XC2300 Derivatives

Errata Sheet

V1.9 2014-10

Figure 1 Critical application reset sequence

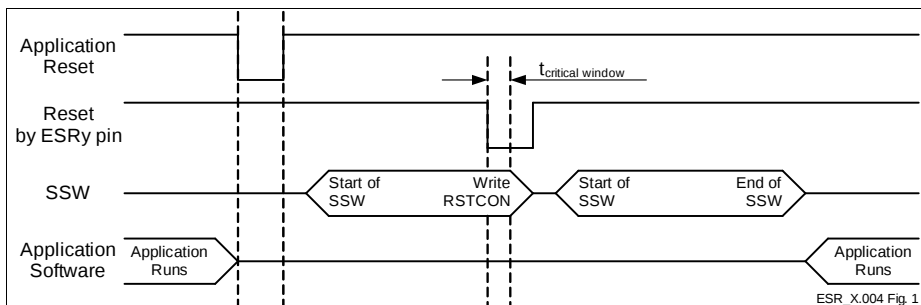
ESR X.004 Wrong Value of SCU_RSTCONx Registers after ESRy Application Reset

SCU_RSTCONx registers are reset only by Power-On, but they may be wrongly affected after a second application reset requested by an ESRy pin. This may lead to the SCU_RSTCONx register values being set to zero, which could unexpectedly disable reset sources within the user application. The conditions which lead to this behavior are:

1. First, an application reset by SW (software), CPU (Central Processing Unit), MP (Memory), WDT (Watchdog Timer) or ESRy (External Service Request y) occurs.
2. Following this, an application reset on an ESRy pin occurs.
3. If the above mentioned ESRy reset occurs during a critical time window of the SSW (startup software), then it's possible that the application will operate with the wrong SCU_RSTCONx register value. The critical time window occurs when the SSW is writing the SCU_RSTCONx registers, and at the same time, the ESRy reset request is processed by the reset circuitry. The width of this critical window $f_{critical\ window}$ is less than 13 cycles.

- Initialize SCU_RSTCONx registers by user software after any reset, or
- assure that a second application reset request with an ESR pin does not occur during the critical time window.

Figure 2 Example for Case 2: Interrupt Service for Task C delayed

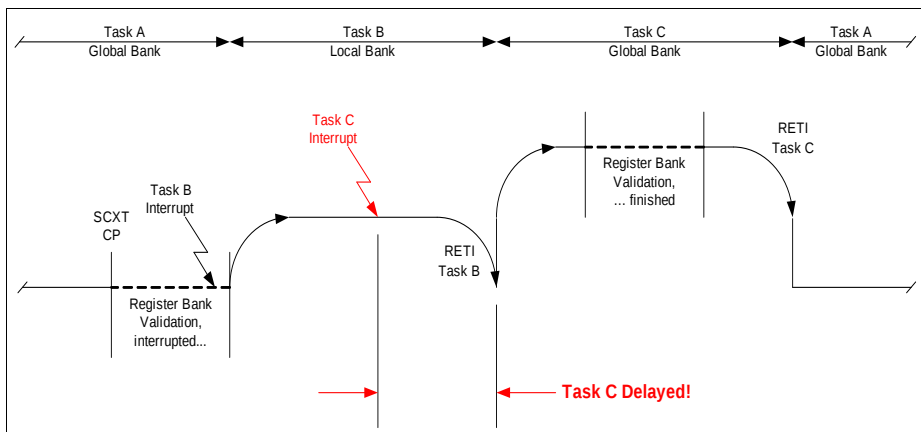
Case 2 (see also Figure 1):

- The Context Pointer CP is written to (e.g. by POP, MOV, SCXT ... instructions) within a routine (Task A) that uses a **global** register bank (bit field PSW.BANK = 00_B), i.e. the context for this routine will be modified,
- This context switch procedure (19 cycles) is interrupted by an interrupt request (Task B) which is programmed (with GPRSELx = 1X_B) to automatically use one of the **local** banks via the bank selection registers BNKSEL0...3 (i.e. the interrupting routine has a priority level ≥ 12),
- Before the corresponding interrupt service routine is finished, another interrupt request (Task C) occurs which is programmed (with GPRSELx = 00_B) to automatically use the **global** bank via the bank selection registers BNKSEL0...3 (i.e. the interrupting routine has a priority level ≥ 13).

In this case service of this interrupt request (for Task C) is delayed until bit field PSW.BANK becomes 00_B after executing the RETI instruction at the end of the routine (Task B) using the local bank.

Workaround for Case 2

When using both local and global register banks via the bank selection registers BNKSEL0...3 for interrupts on levels ≥ 12 , ensure that there is no interrupt using a global register bank that has a higher priority than an interrupt using a local register bank.

Figure 7 External Clock Drive XTAL1

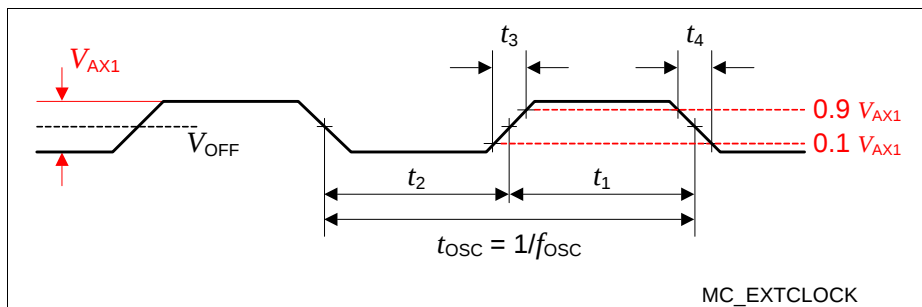
In the Data Sheet section "External Clock Input Parameters" the following table and figure should be updated (major changes are marked **red**).

1) The amplitude voltage V_{AX1} refers to the offset voltage V_{OFF} . This offset voltage must be stable during the operation and the resulting voltage peaks must remain within the limits defined by V_{IX1} .

Note: For crystal or ceramic resonator operation, it is strongly recommended to measure the oscillation allowance (negative resistance) in the final target system (layout) to determine the optimum parameters for oscillator operation. The manufacturers of crystals and ceramic resonators offer an oscillator evaluation service. This evaluation checks the crystal/resonator specification limits to ensure a reliable oscillator operation.
